STATE OF MAINE  
DEPARTMENT OF MARINE RESOURCES  
21 STATE HOUSE STATION  
AUGUSTA, MAINE  
04333-0021

June 21, 2025

**Subject: MDMR Comments on 401 Water Quality Certification Applications for the Lockwood (P-2574), Hydro-Kennebec (P-2611), Shawmut (P-2322), and Weston (P-2325) Hydroelectric Projects**

Figure 1: River Herring captured at Lockwood Dam (primary axis) and Milford and Benton Dams (secondary axis). Red diamond indicates the start of nighttime shutdowns at Lockwood.

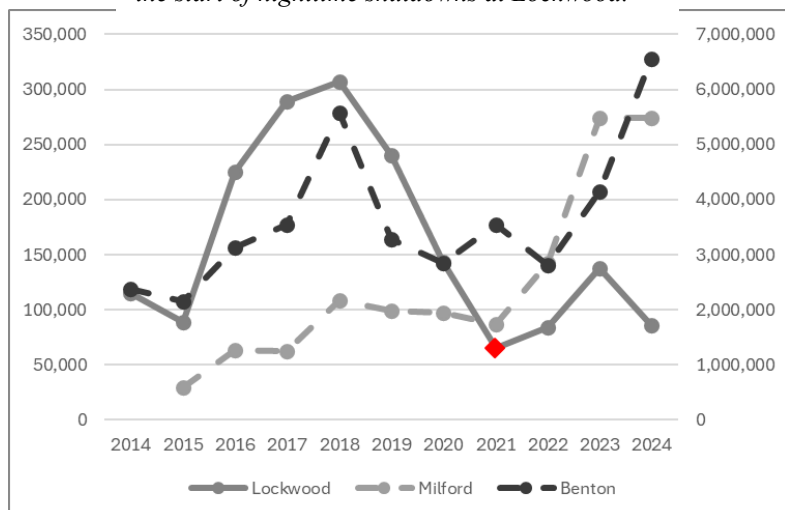
Upstream Fish Passage: As the lowermost dam on the river, safe, timely, and effective volitional upstream fish passage at the Lockwood Project is essential. MDMR agrees with FERC's findings related to continued operation of the fish lift and need for 24 hour operations. Summer low flows at the Lockwood project will continue to result in most of the water moving through the turbines and drawing fish to the fish lift and away from the new volitional fishway. Under these lower flow conditions, fish are more likely to attempt passage at the fish lift. During June and July, when river temperatures do not allow handling of salmon, it will be especially important to have the ability to capture salmon in the fish lift and allow them to volitionally swim upstream. This would also reduce handling stress on river herring and American shad. Based on fish passage timing and flow duration curves, river flow exceeds the maximum powerhouse capacity of 6,236 cfs approximately 65% of the time in May, 48% of the time in June, and 20% of the time in July. Due to this shift in flows, the attraction to the fish lift increases as the migration season progresses. Given the expected increase in fish numbers due to new upstream passage and varying attraction flows, the Lockwood fish lift will become a bottleneck for river herring if not converted to a swim-through facility. Currently and into the future, not all fish can be moved at the current fish lift as it is not connected to the headpond and cannot be operated at night when trap and truck operations cannot be carried out safely.<sup>56</sup> Additionally, the fish lift cannot currently operate 24

Downstream Fish Passage: To ensure safe, timely, and effective downstream passage, Brookfield has initiated nighttime turbine shutdowns to reduce the likelihood of entrainment of out-migrating smolts. While these shutdowns may achieve the intended 97% of smolt out-migration, it fails to provide similar protection for river herring, American shad, American eels, and sea lamprey due to their migration timing (Supplemental Table 1). For example, the annual timing of these shutdowns relies on either 1) trapping of wild smolts in the watershed or 2) a smolt timing model that relies on air temperature in upstream rearing habitat for the first 90 days of a given year as a predictor of smolt migration timing. The proposed downstream passage measures fail to include actions that will reduce entrainment and other impacts during downstream passage for most diadromous species.<sup>62</sup>
